# CITY OF ALBUQUERQUE

**Re: Fuentes Auto Sales**  
**700 Gibson Blvd. SE**  
**Traffic Circulation Layout**  
Engineer's/Architect's Stamp XX-XX-XX (L14-D010)

Based upon the information provided in your submittal received 08-17-23, the above referenced plan cannot be approved for Building Permit until the following comments are addressed:

PROPOSED SITE PLAN  
SCALE: 1"=20'

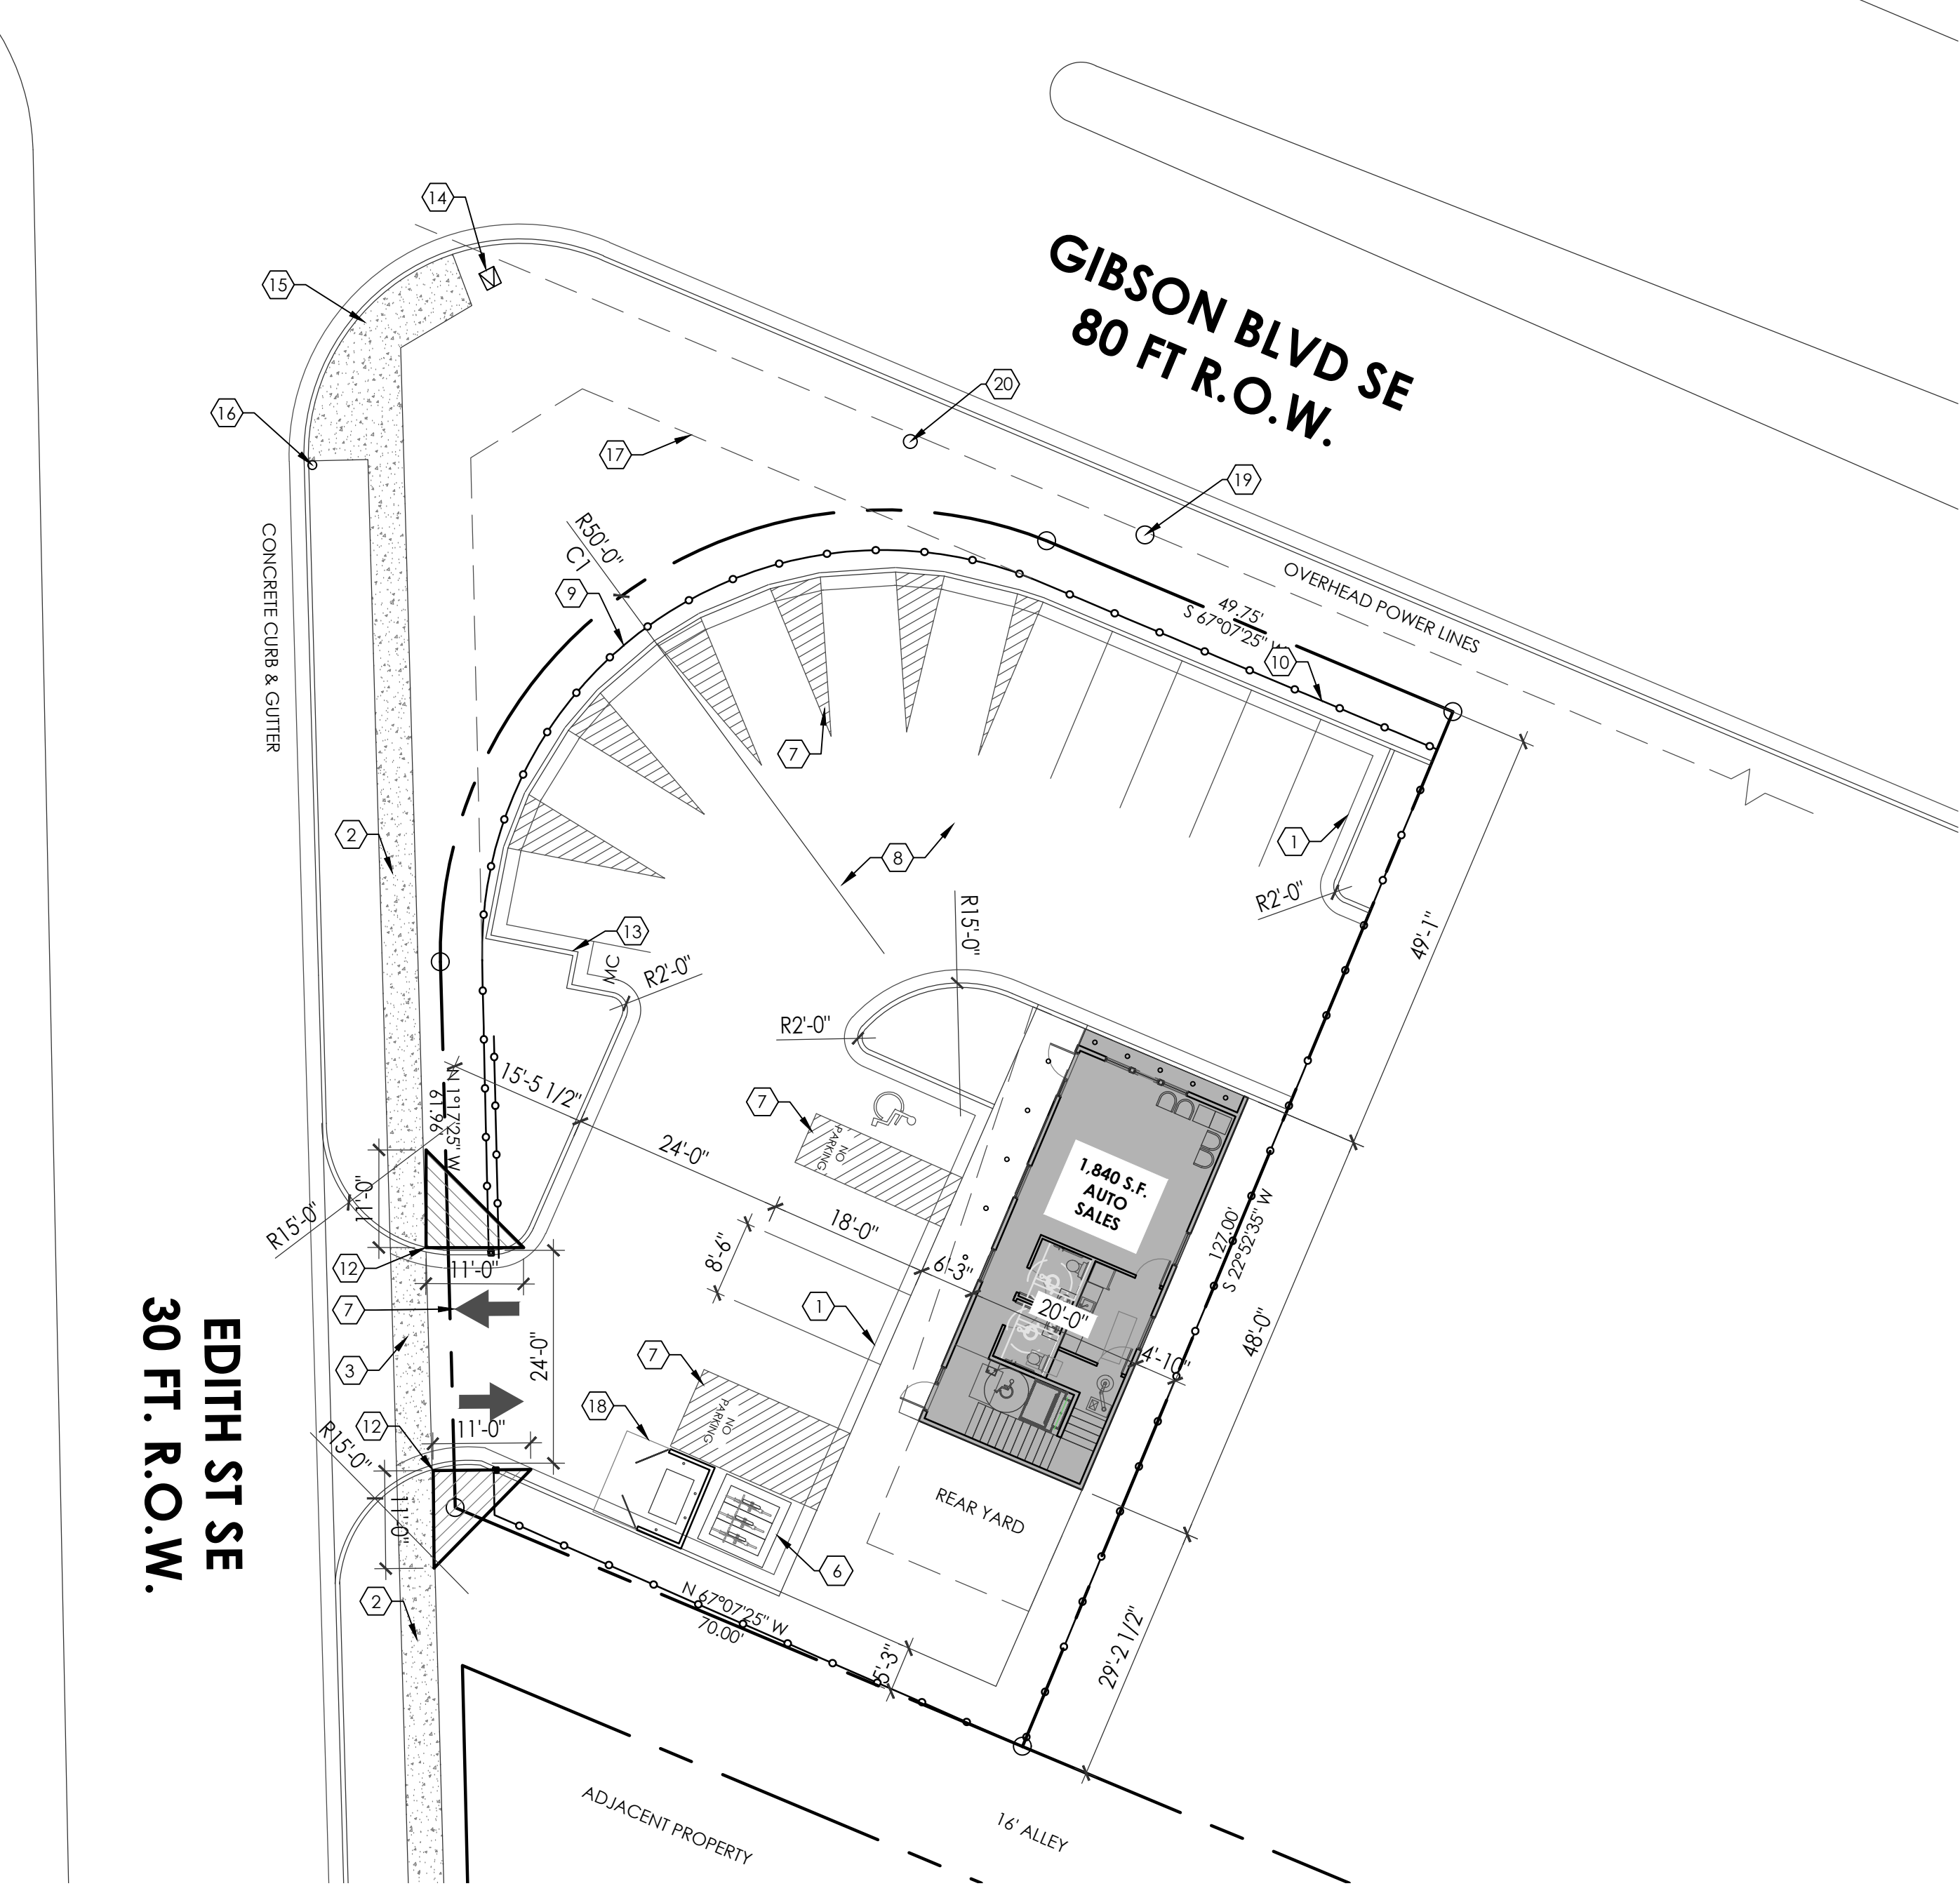
1. The traffic circulation layout must be stamped, signed, and dated by an engineer or architect licensed in the state of New Mexico.
2. 6 ft. wide sidewalk must be built along Gibson Blvd. from property line to property line. For sidewalk waiver, please contact Ernest Armijo [earmijo@cabq.gov](mailto:earmijo@cabq.gov)
3. Minimum distance from the commercial site access to the intersection is 75 ft. please show this dimension on the site plan.
4. Please provide ADA ramps at the proposed site access or reference COA std dwg.
5. ADA curb ramp at the corner of Gibson Blvd. and Edith St. must be updated to current standards and has truncated domes installed.
6. Identify all existing access easements and rights of way width dimensions.
7. Please list the width and length for all existing and proposed parking spaces. Some dimensions are not shown.
8. The minimum parking stall dimensions are:

9. The ADA accessible spaces must include an access aisle. Van accessible aisles should be 8ft wide; all others should be 5ft wide.

10. Per the IDO, a 6 ft. wide ADA accessible pedestrian pathway is required from the public sidewalk to the building entrances. Please clearly show this pathway and provide details.

11. Per DPM, a 6 ft. wide ADA accessible pedestrian pathway is required from the ADA parking stall access aisles to the building entrances. Please clearly show this pathway and provide details.

12. ADA accessible pedestrian pathway should not be placed behind parking space or adjacent to a vehicular way. Vehicle and pedestrian/wheel chair conflicts should be avoided as much as possible.

16. Please add a note on the plan stating "All improvements located in the Right of Way must be included on the work order."
17. Traffic Studies: See the Traffic Impact Study (TIS) thresholds. In general, a minimum combination of 100 vehicles entering and exiting in the peak hour warrants a Traffic Impact Study. Visit with Traffic Engineer for determination, and fill out a TIS Form that states whether one is warranted. In some cases, a trip generation may be requested for determination (**Contact Matt Grush: [mgrush@cabq.gov](mailto:mgrush@cabq.gov)**).

**E** REFUSE ENCLOSURE - PLAN AND SECTION  
SCALE: 1/4"=1'-0"

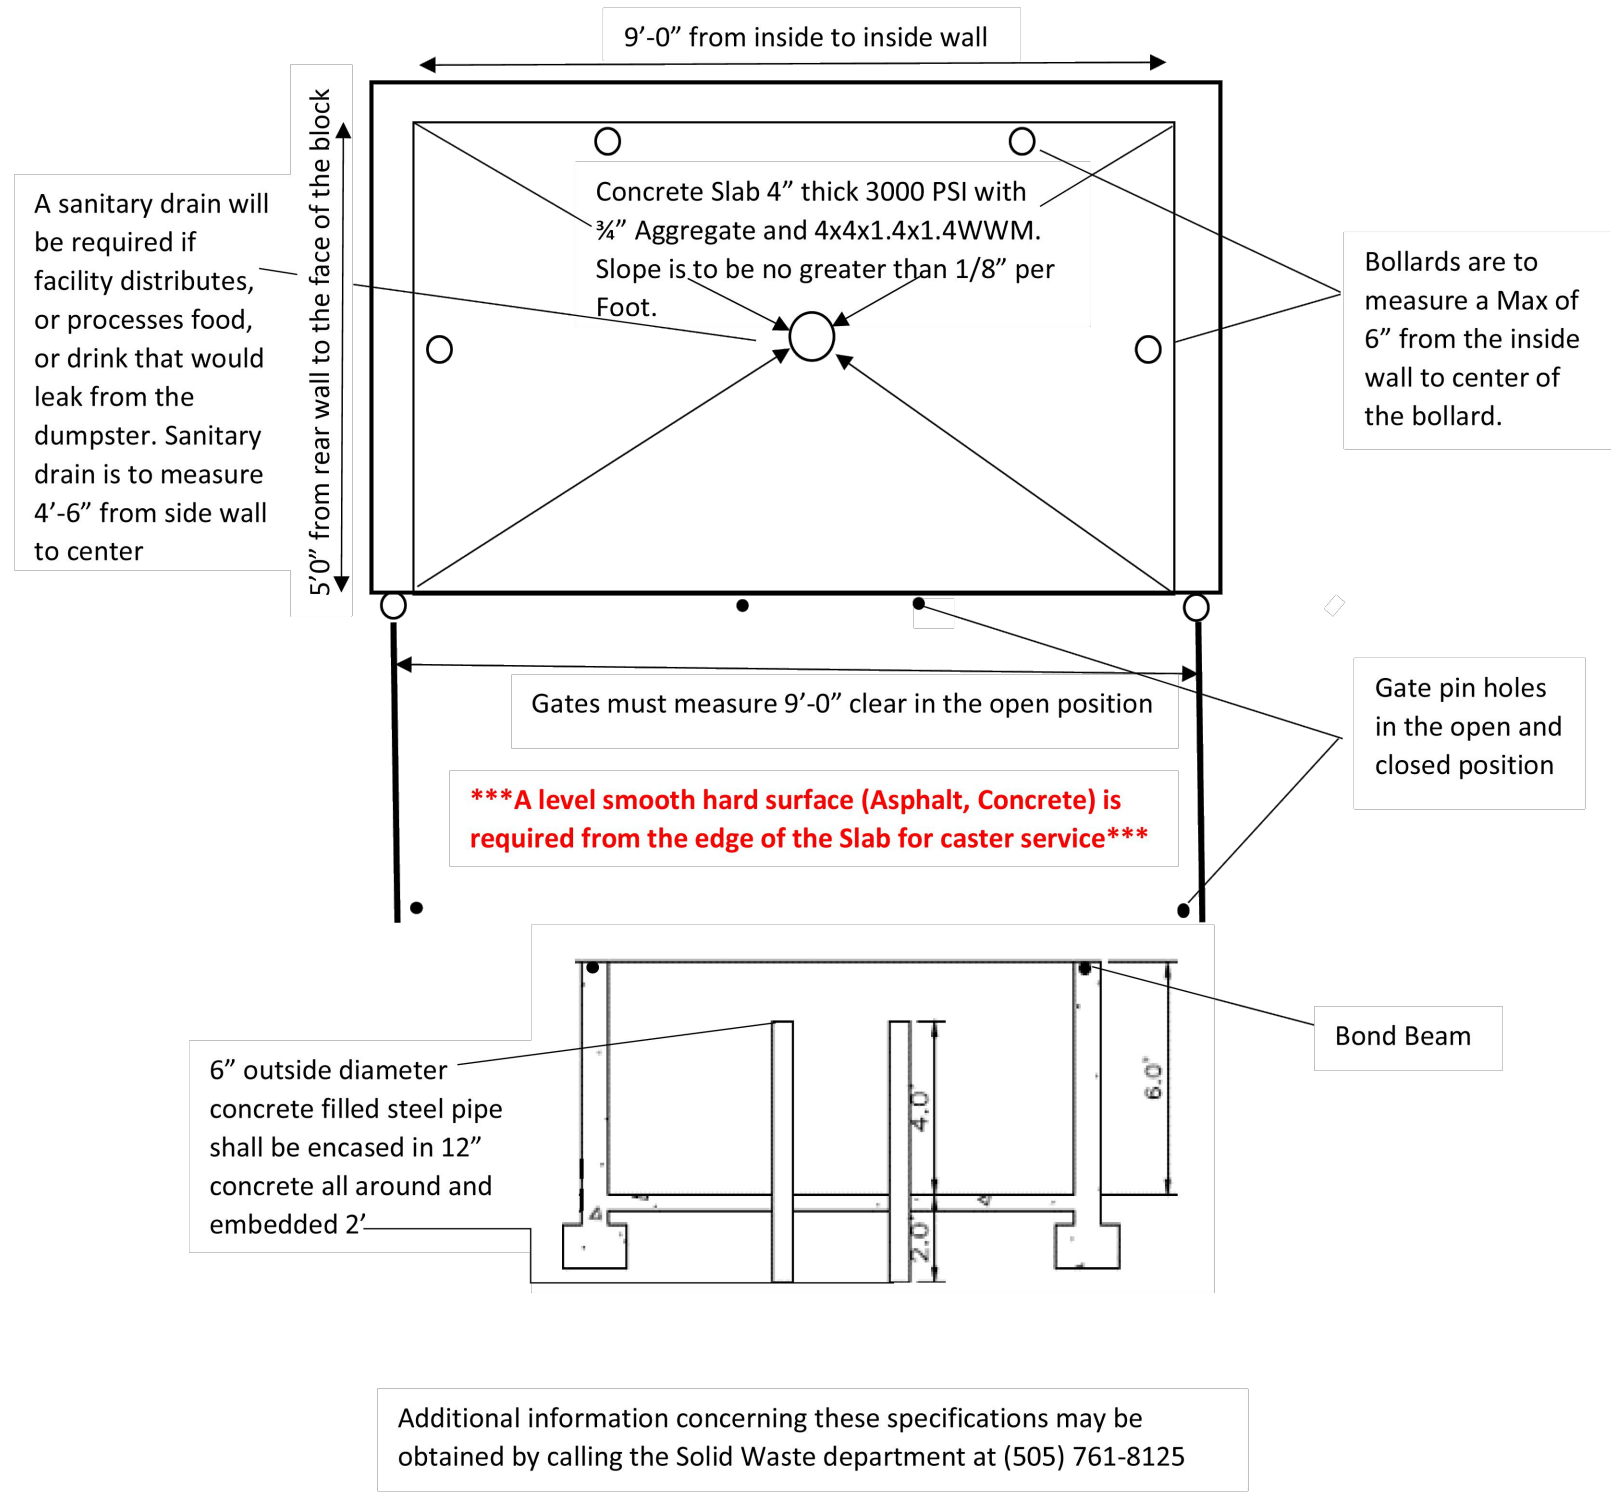
13. Please remove trash enclosure details from TCL-2.
14. Provide a copy of Fire Marshal and Solid Waste approval.
15. Work within the public right of way requires a work order with DRC approved plans.
